Basis of this breakdown

1. Bulletin 3 (M-529 / M-530 / M-531, revision 4, 08/10/2026) was issued after the ductwork in the affected areas had been fabricated and installed per the Addendum 1 drawings. The change therefore includes **disconnecting and removing installed ductwork**, in addition to fabricating and installing the revised work.

Snowflake Fitout - 7 Times Square, Floors 29-31 | COP-SF-05 Bulletin 3 Revision

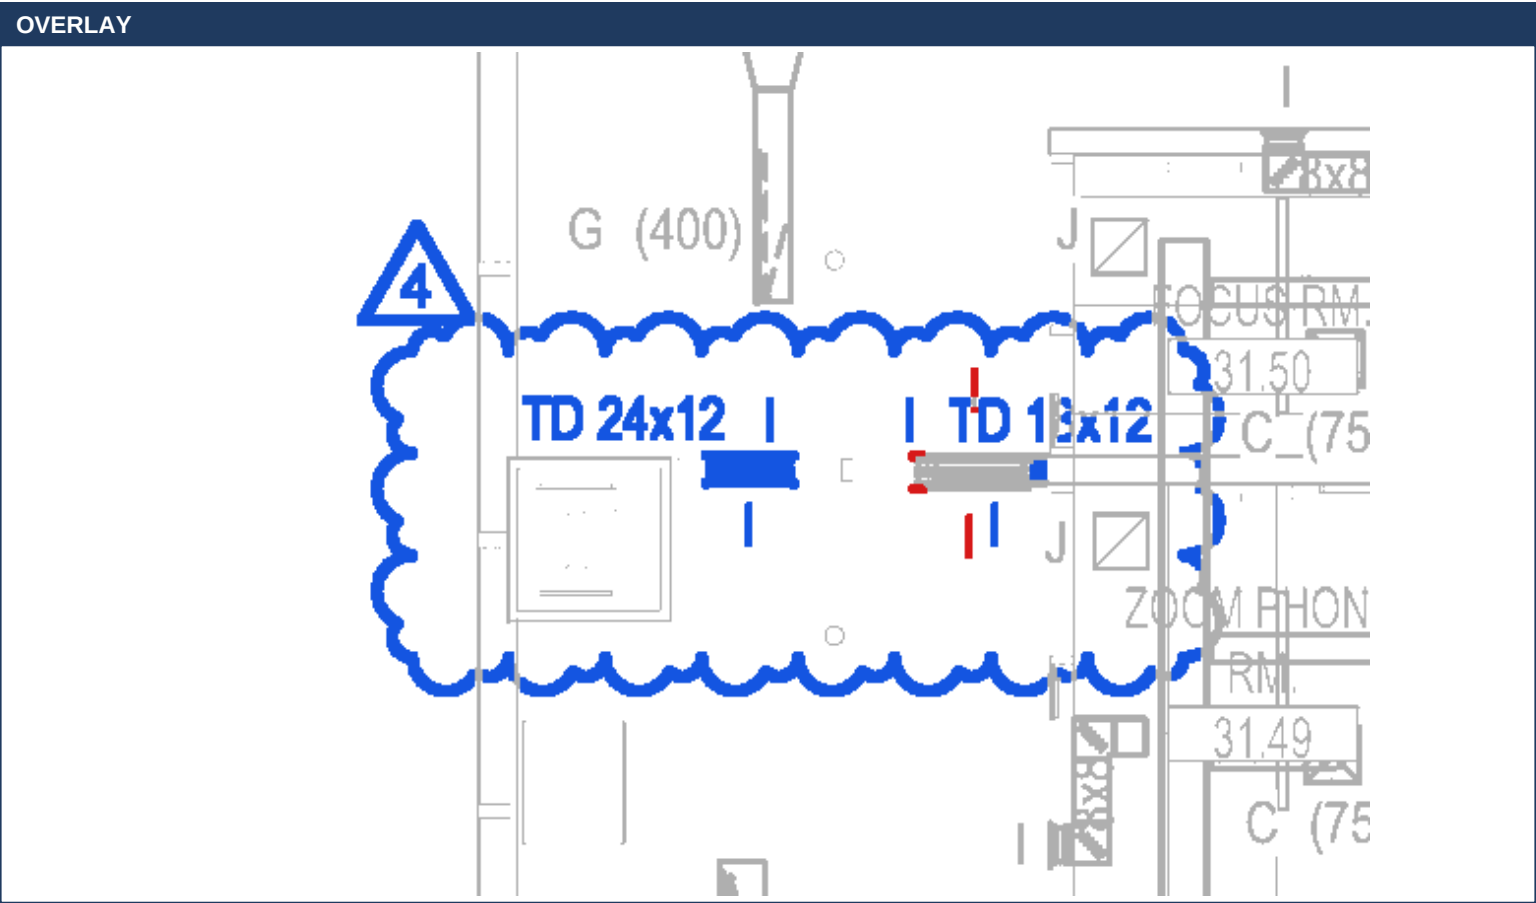
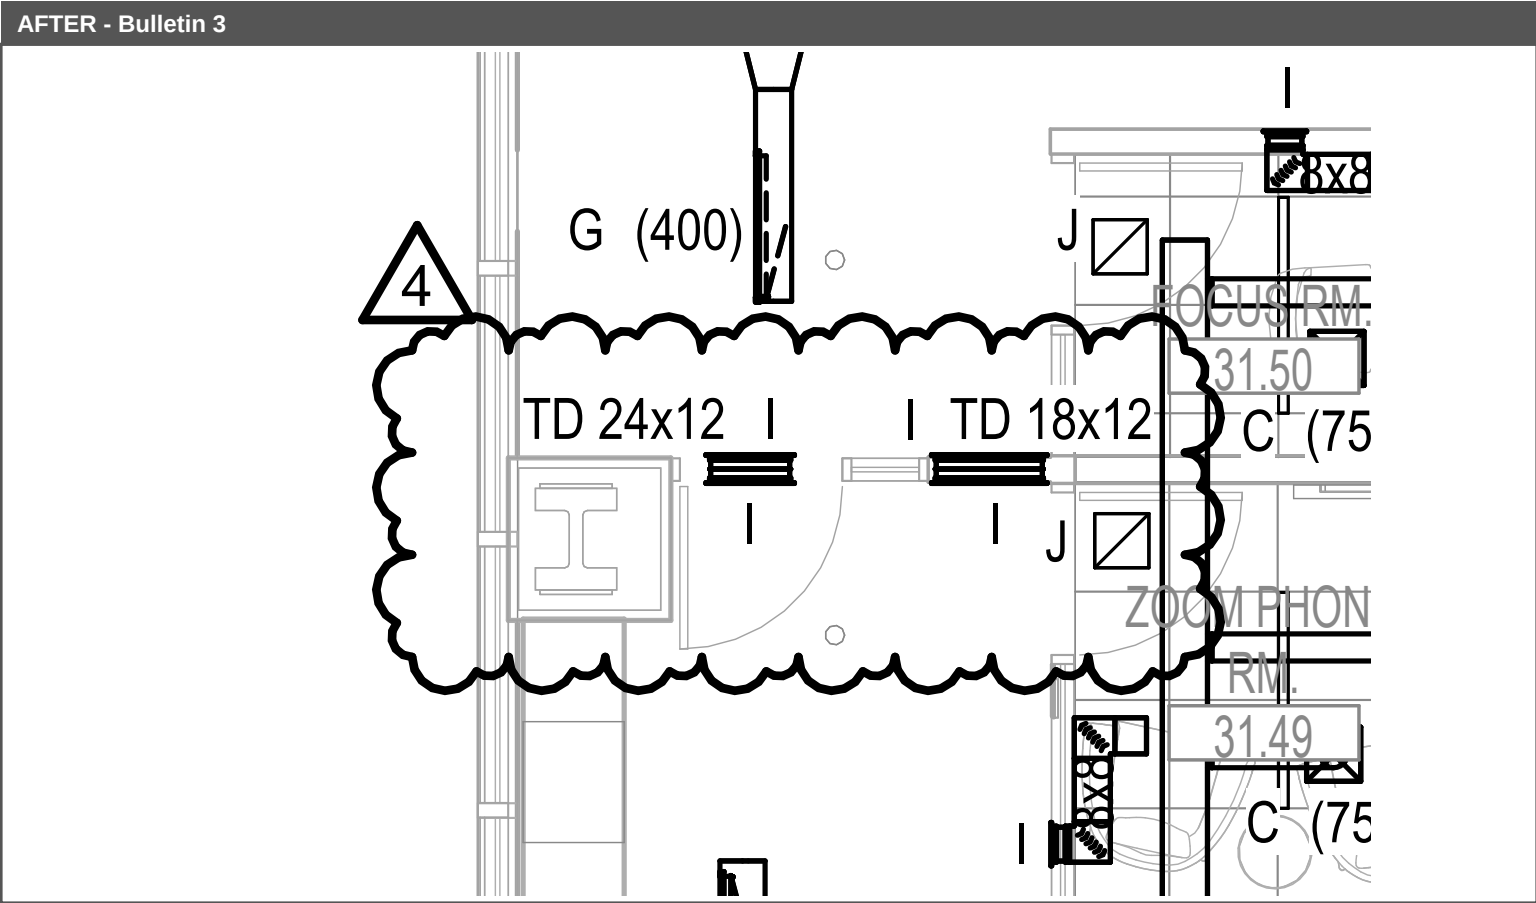
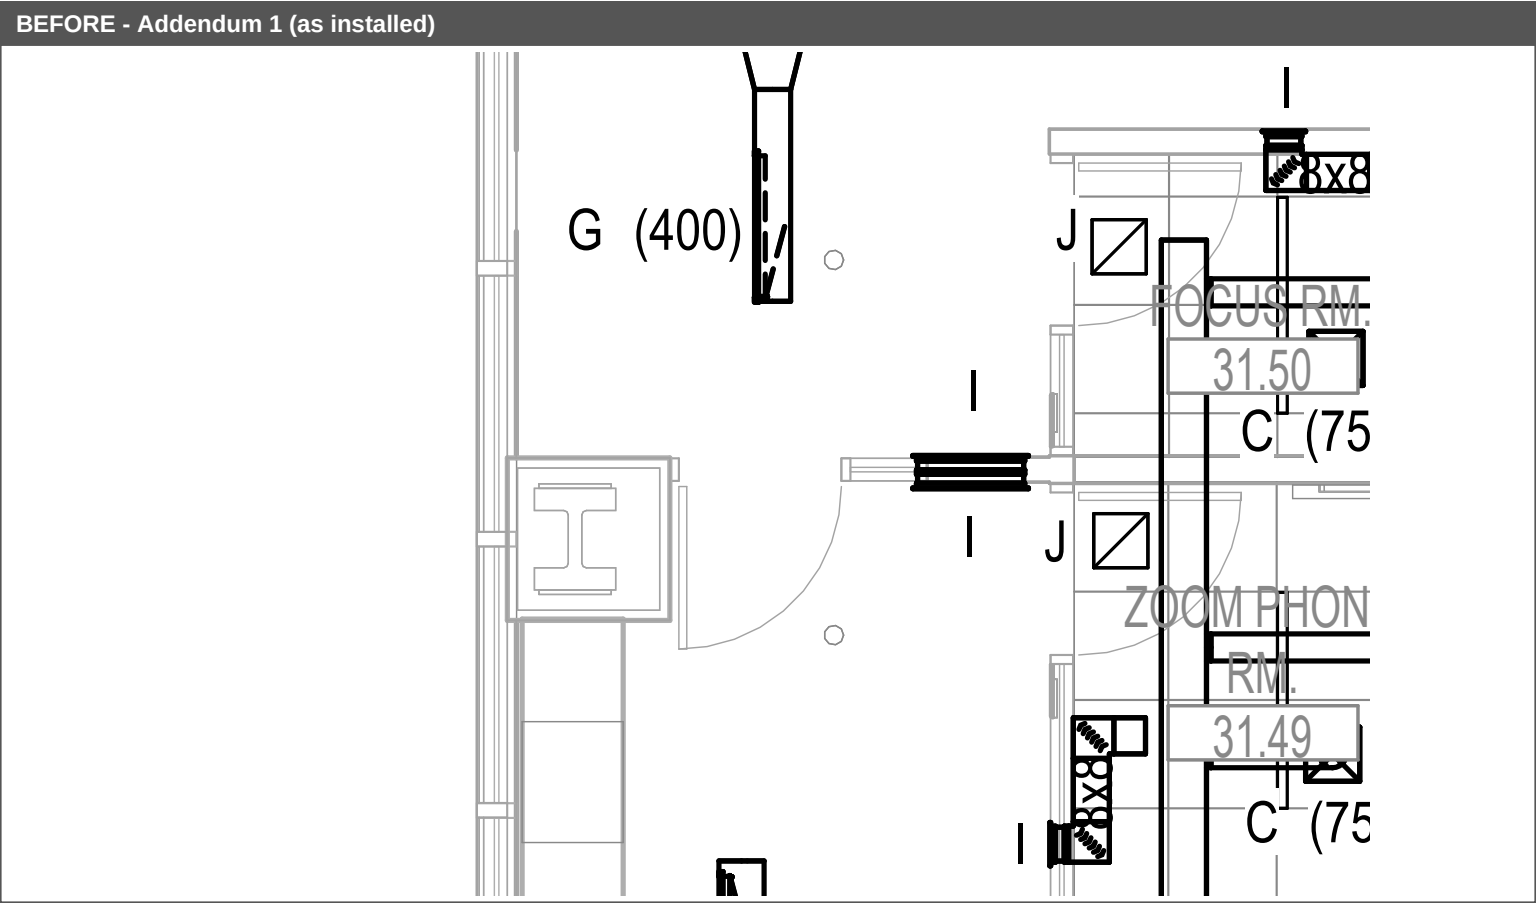
Before (Addendum 1, installed): (1) transfer duct (not sized on Addendum 1).

After (Bulletin 3): TD 24x12 and new TD 18x12.

Work required: Remove existing transfer duct; fabricate and install TD 24x12 and TD 18x12.

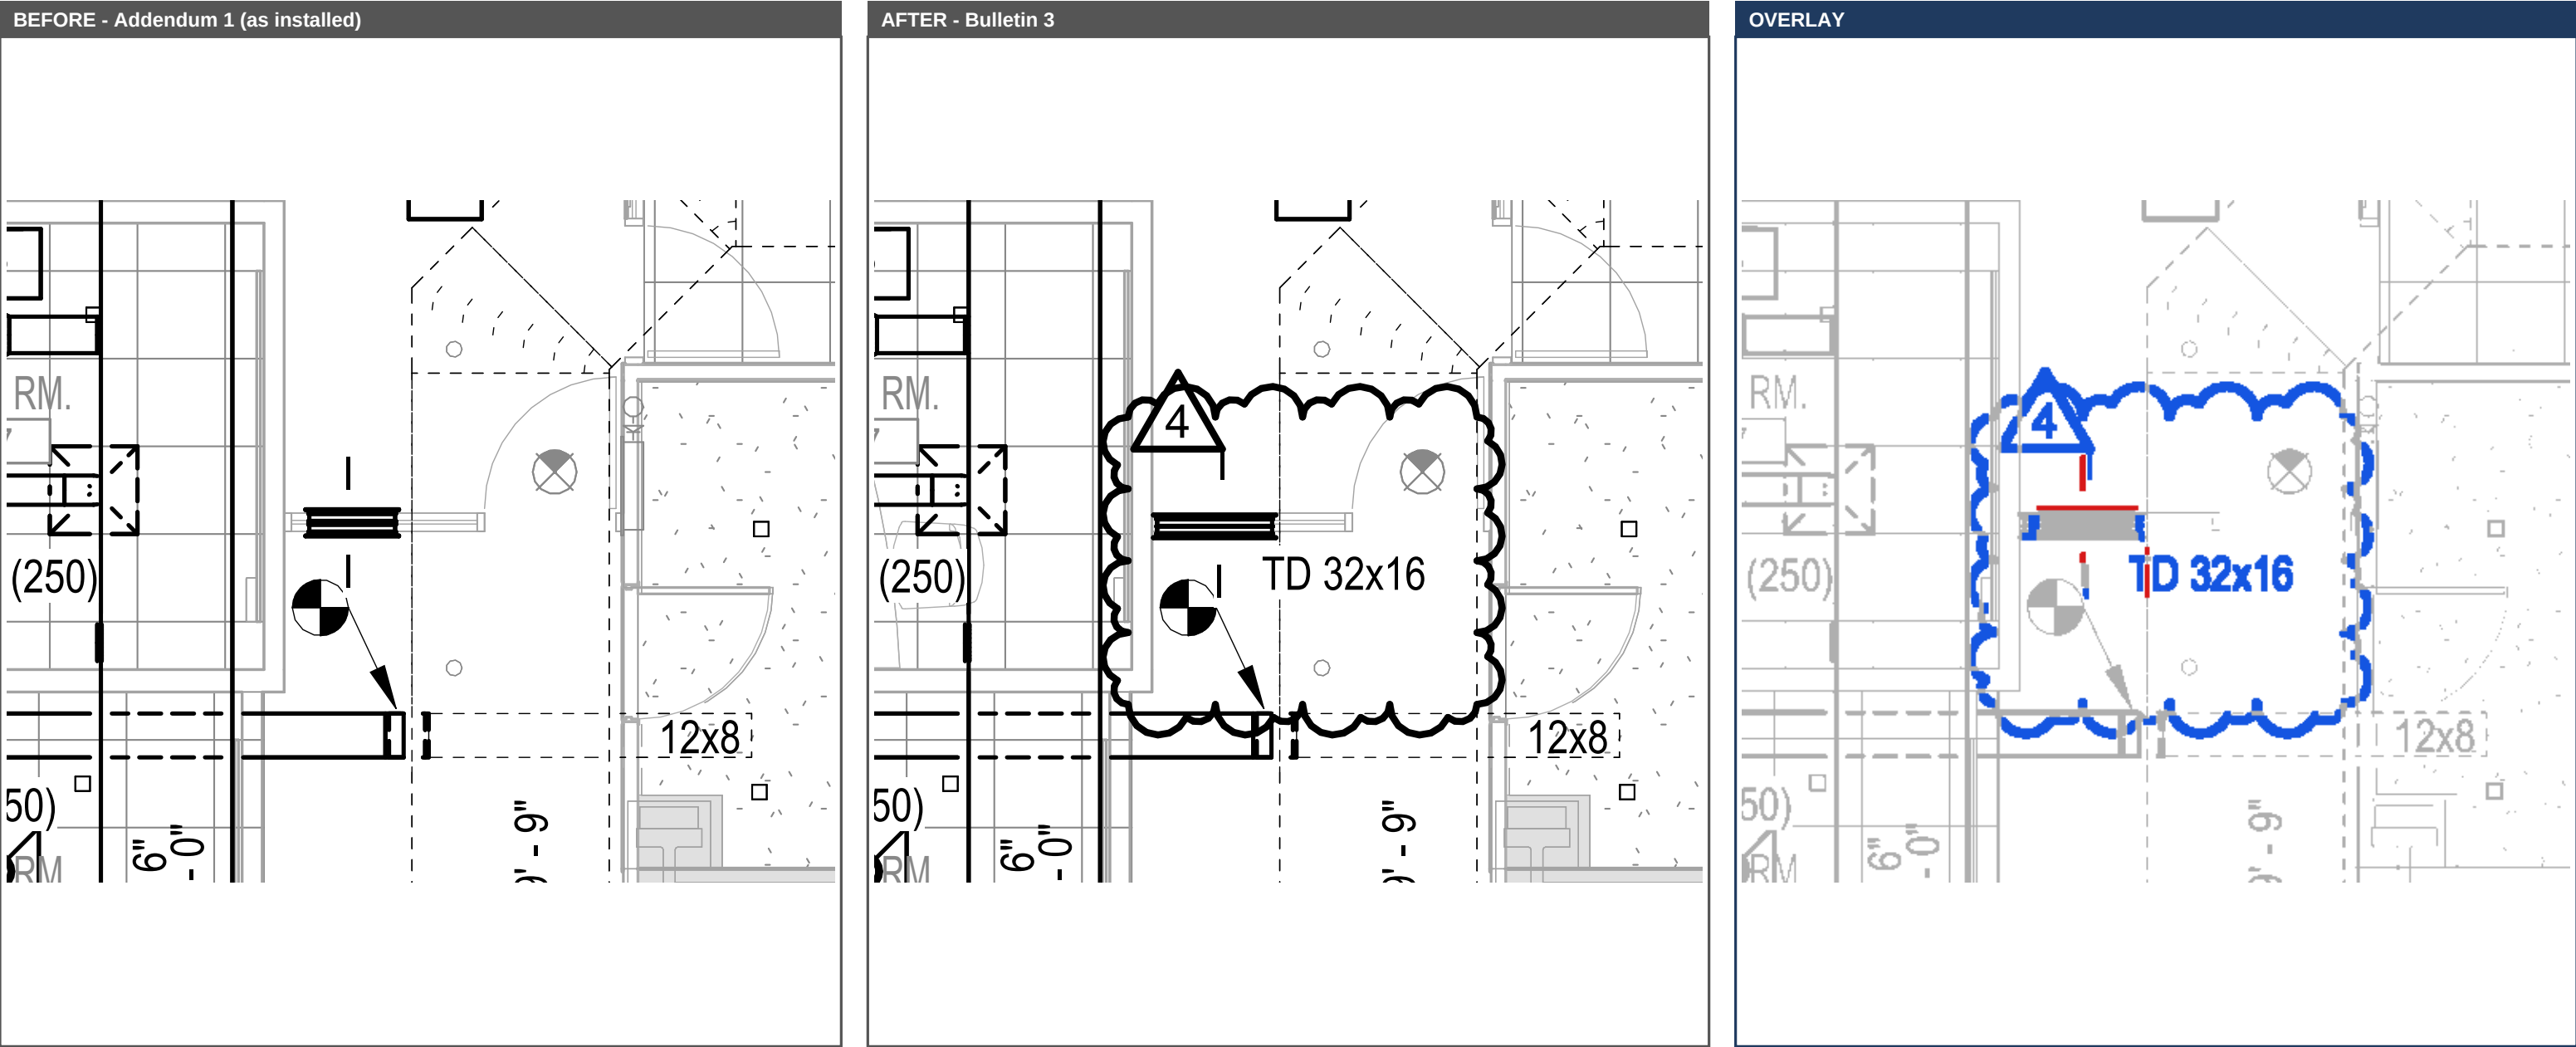
Before (Addendum 1, installed): Transfer duct as installed per Addendum 1 (not sized on Addendum 1).

After (Bulletin 3): Transfer duct revised to TD 32x16.

Work required: Remove installed transfer duct; fabricate and install TD 32x16.

Area 31-3 - Storage 31.02 - new transfer ducts

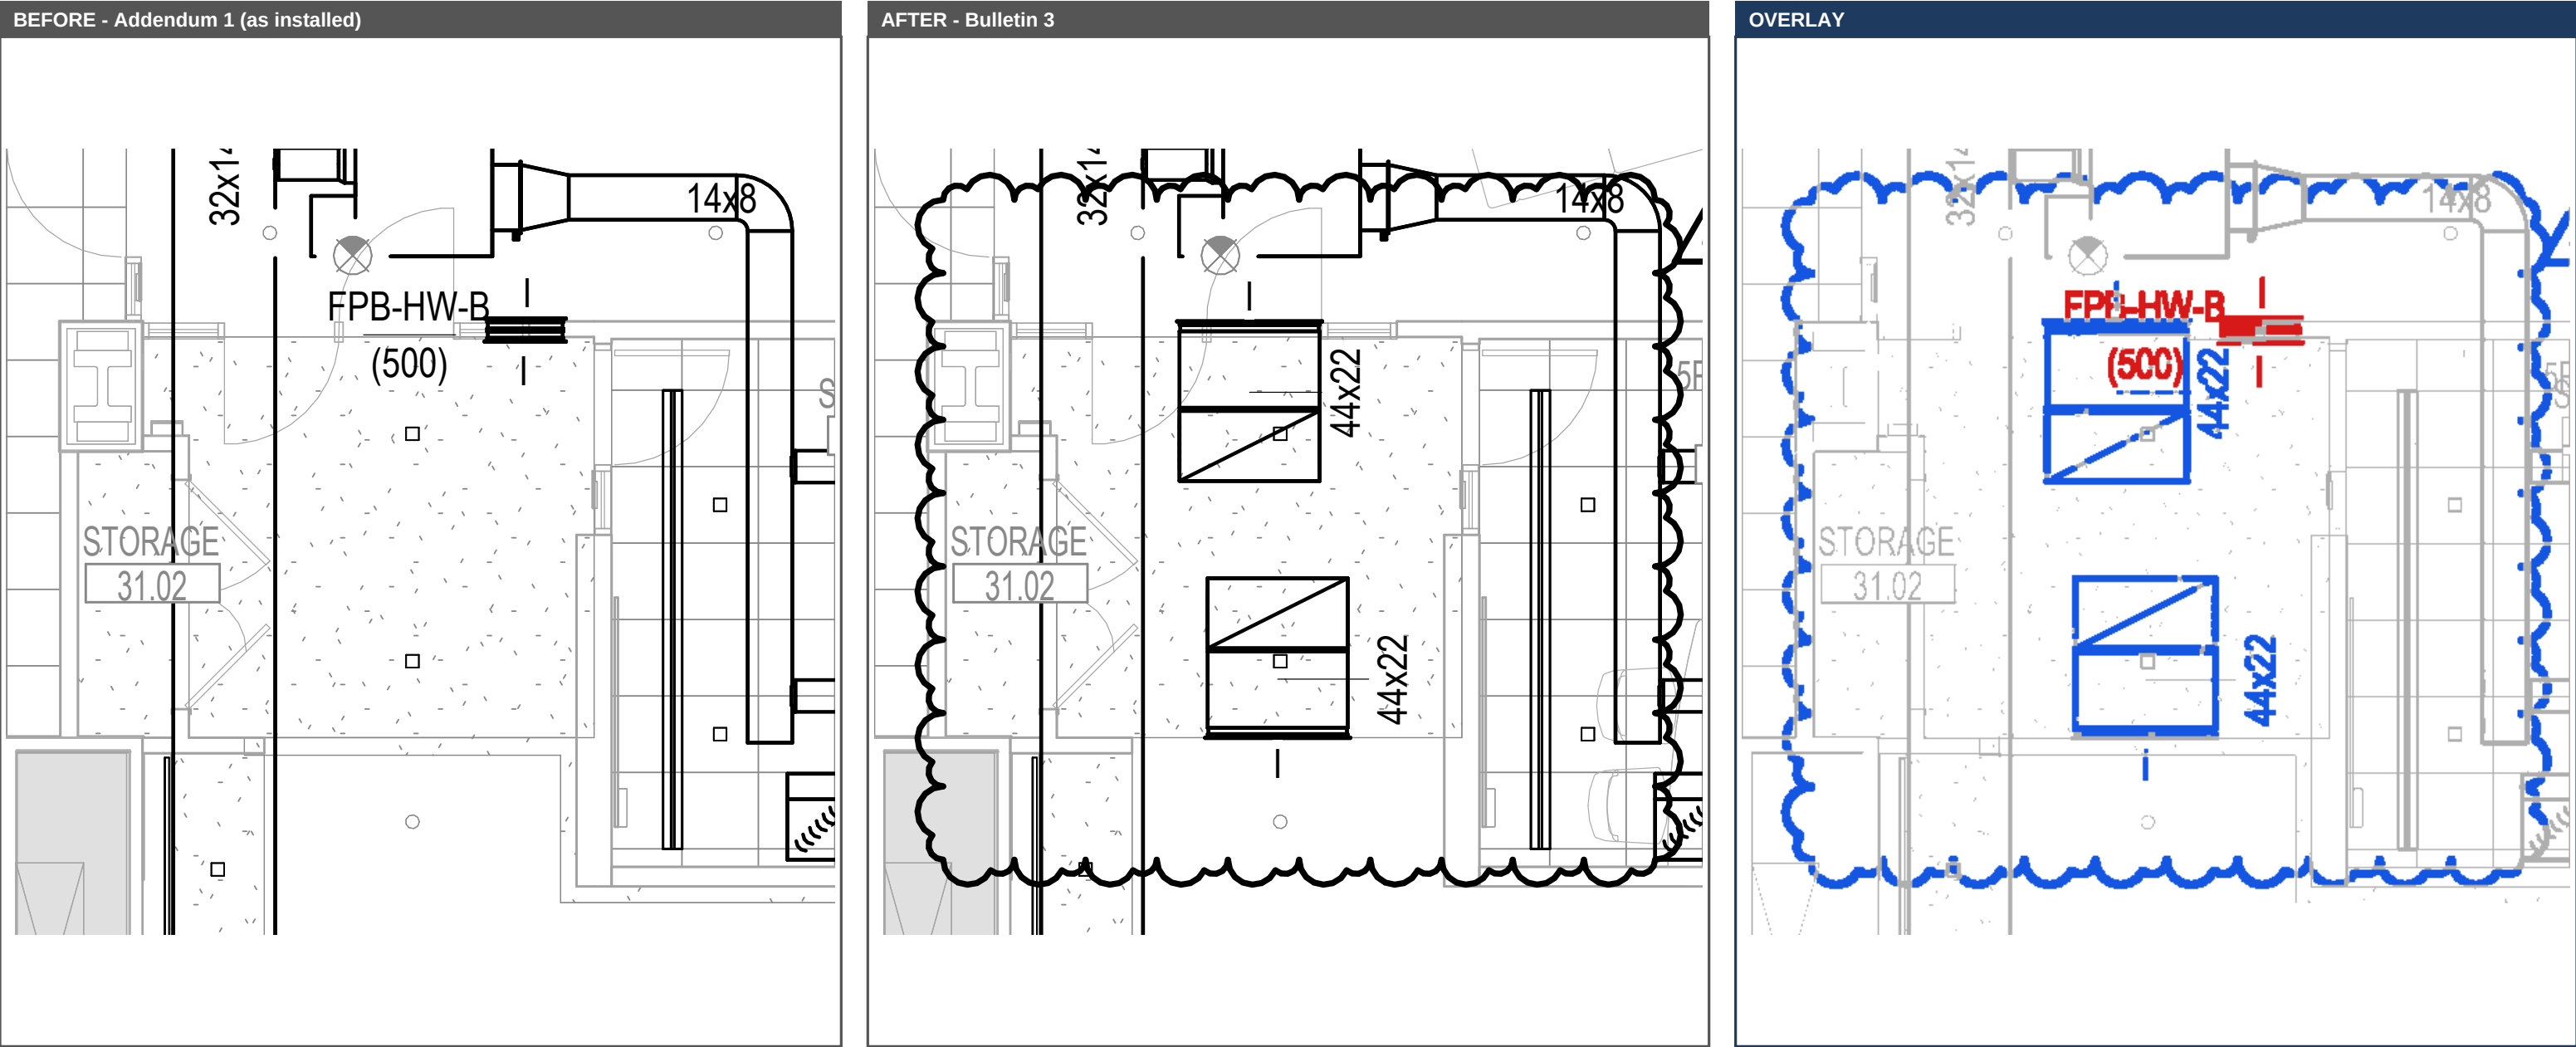
Before (Addendum 1, installed): No transfer ducts; volume damper at FPB-HW-B (500) branch.

After (Bulletin 3): (2) new 44x22 transfer ducts.

Work required: Remove affected branch fitting; fabricate and install (2) 44x22 lined transfer ducts.
